U S NAVY RESPONSE TO COMMENTS ON RCRA FACILITY INVESTIGATION WORK PLAN
SOLID WASTE MANAGEMENT UNIT 474 (SWMU 474) MCB CAMP LEJEUNE NC
2/18/2009
CH2M HILL

RESPONSE TO COMMENTS
RCRA Facility Investigation (RFI) Work Plan
SWMU 474
MCB Camp Lejeune, North Carolina

DATE: February 18, 2009

Figure 4-1
Proposed Sampling Locations
SWMU 474 RFI
MCB Camp Lejeune
North Carolina

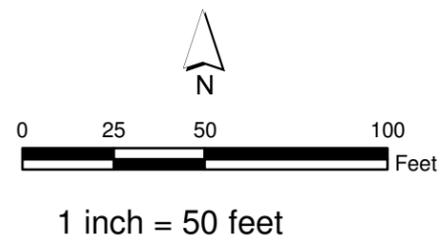
2. In Section 5.3.6, it is not clear how the location of the 4 permanent monitoring wells will be determined. The criteria for locating the wells should be included.

The criteria for determining the locations of the 4 permanent monitoring wells is discussed in Section 5.3.4, *Permanent Monitoring Well Installation*. The first paragraph under the *Permanent Monitoring Well Installation* sub-heading has been revised as follows, *“Following critical evaluation of the laboratory analytical data derived from analysis of groundwater samples collected from the temporary wells, in addition to historical (November 2006 CSI) groundwater analytical data, CH2M HILL will, if necessary, make recommendations for the citing of additional permanent groundwater monitoring wells. Water level measurements will be collected at each of the temporary wells and used to determine groundwater flow direction within the vicinity of the SWMU. The proposed permanent wells would be constructed during a second mobilization using hollow stem auger (HSA) drilling techniques. One permanent shallow well will be installed near the suspected VOC source area (SWMU474-TW08), two permanent wells will be installed laterally from the suspected VOC source area, and one permanent well will be installed as a non-impacted well hydraulically downgradient from the suspected source area. In addition, temporary well SWMU474-TW09 will be converted to a permanent well to serve as a non-impacted well located hydraulically upgradient of the suspected source area.*
